DEVELOPMENT APPLICATION ASSESSMENT REPORT

Application Number:	DA2020/0129
Responsible Officer:	Anne-Marie Young
Land to be developed (Address):	Lot 2 DP 18143, 4 Lewis Street BALGOWLAH HEIGHTS NSW 2093
Proposed Development:	Demolition of an existing dwelling and Construct new two storey dwelling
Zoning:	Manly LEP2013 - Land zoned R2 Low Density Residential
Development Permissible:	Yes
Existing Use Rights:	No
Consent Authority:	Northern Beaches Council
Land and Environment Court Action:	No
Owner:	Koji Nedachi
Applicant:	Novam Design Studio Eyal Snehor
Application Lodged:	14/02/2020
Integrated Development:	No
Designated Development:	No
State Reporting Category:	Residential - Single new detached dwelling
Notified:	02/03/2020 to 16/03/2020
Advertised:	Not Advertised
Submissions Received:	1
Clause 4.6 Variation:	Nil
Recommendation:	Approval
Estimated Cost of Works:	\$ 1,100,000.00

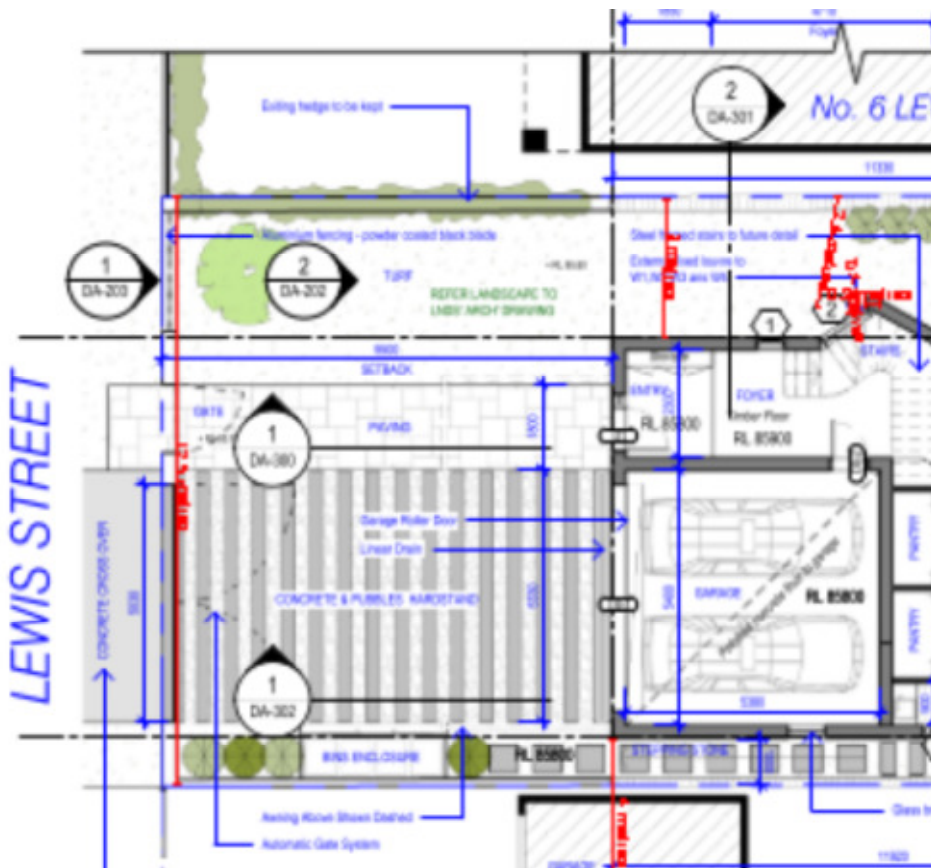
A masonry and timber fence currently provides the boundary treatment to the street frontage which is consistent with the streetscape. The proposed front fence comprises a masonry wall low wall and piers (finished with off white tiles) with a powder coated black metal fence and gates to a height of 1.8m. The contemporary metal posts are considered to be acceptable as they complement the architectural style of the proposed dwelling subject to being 30% transparent. The proposed off white tiles to the masonry walls of the fence are however inconsistent with the street and a condition requires that the masonry wall be rendered and painted in a dark colour. A condition also requires the fence to have a maximum height of 1.5m. The proposed planting along the western boundary of the site will soften the treatment to the street.

A condition requires the height of the fence to be a maximum of 1.5m and at least 30% of the fence is to be transparent in accordance with the control.

Section showing the location of the aluminium roller shutter.

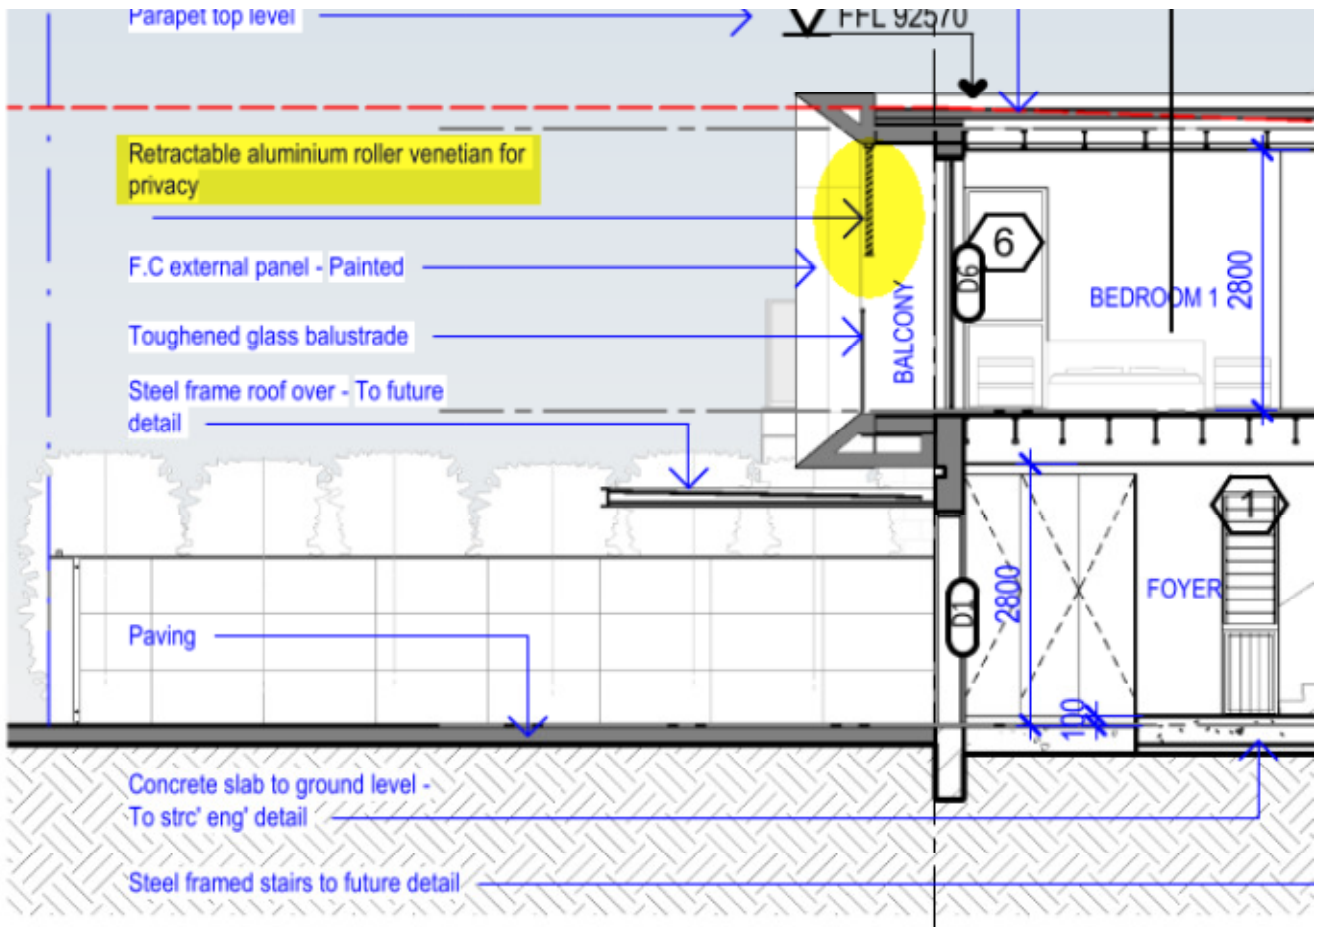
A retractable aluminium roller venetian is proposed to the outer edge of the first floor balcony to the bedrooms fronting the street, refer to image below. The roller blind when in use will not allow for passive surveillance of the public street contrary to the provisions of clause 3.10.2. A condition requires the shutter to be removed.

- The pergola shall be deleted from the proposal;
- The front boundary fence shall have a maximum height of 1.5m at least 30 percent of the fence is open/ transparent and the masonry low wall and pier shall be rendered and painted in a dark earthy colour;
- The paving on the public footpath shown on the landscape drawing shall be deleted, and
- The aluminium retractable venetian shall be deleted from the first floor balcony on the west elevation

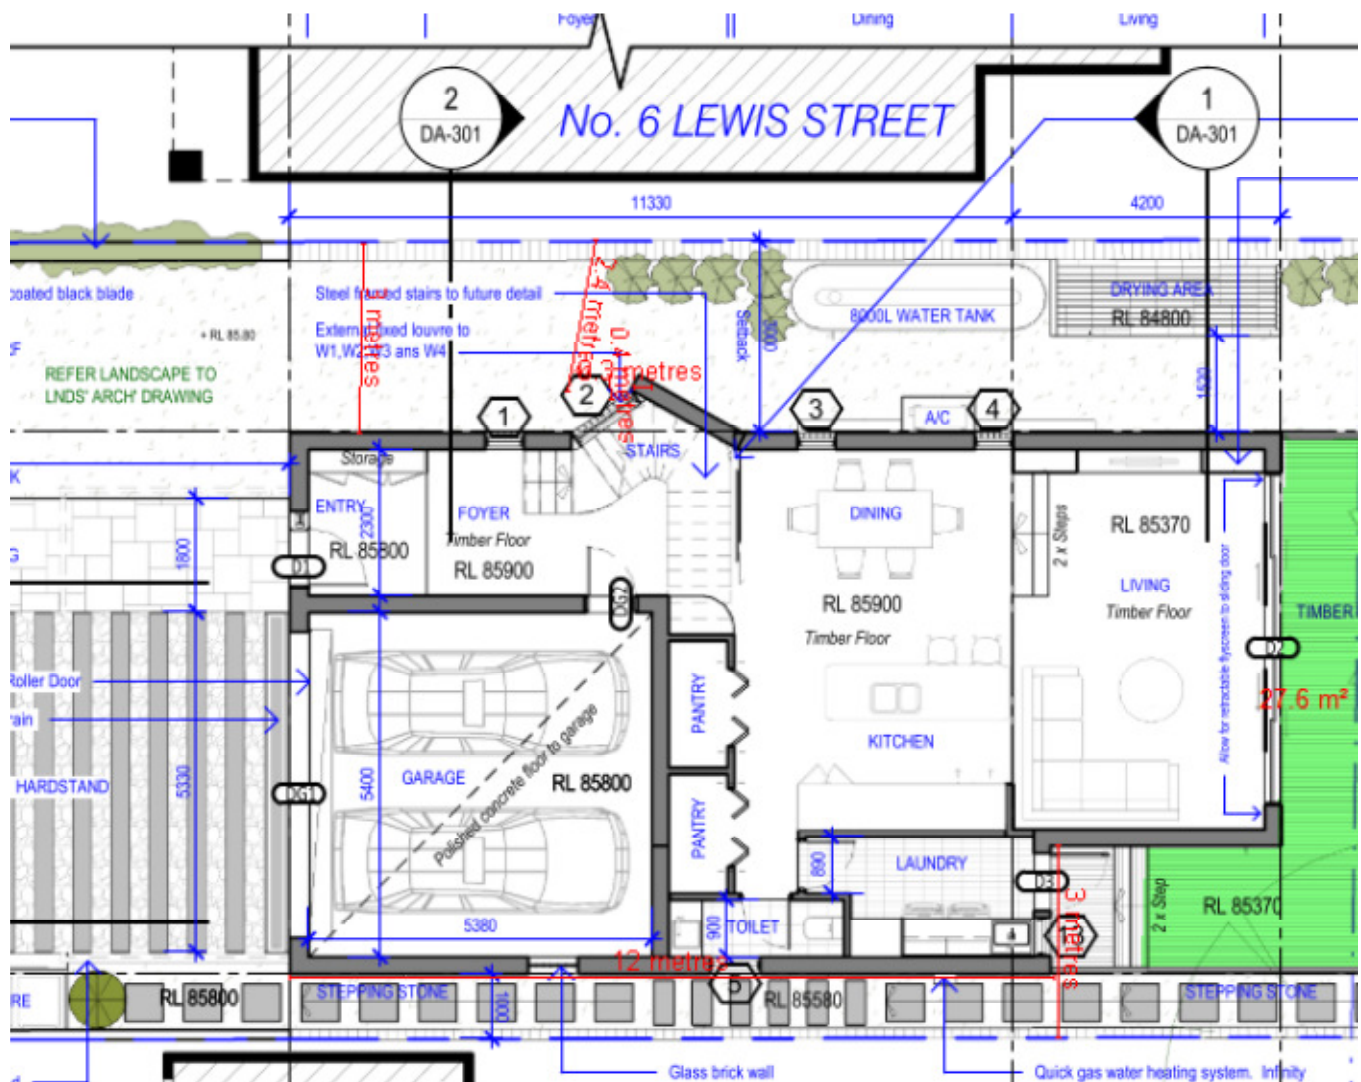
The proposed dwelling has a wall height of between 6.5m to 7m which will require a side setback of 2.1m to 2.3m. The proposal has a 1m set back at ground floor to the southern boundary for a length of 12m which relate to the garage, toilet and laundry. The setback increases to 3m to the rear of the dwelling and for the entire length of the upper floor, refer to plan below. The minor variation of the setback at ground level on the southern boundary is assessed as acceptable given that the non-complying element primarily relates to the proposed garage which is sited adjacent to the garage on the adjoining site to the south No. 2 Lewis Street. It is also noted that the proposed side setbacks of the upper floor are considerably greater than the setbacks to the existing house. The proposal will reduce impacts on residential amenity of the adjoining dwelling in terms of solar access.
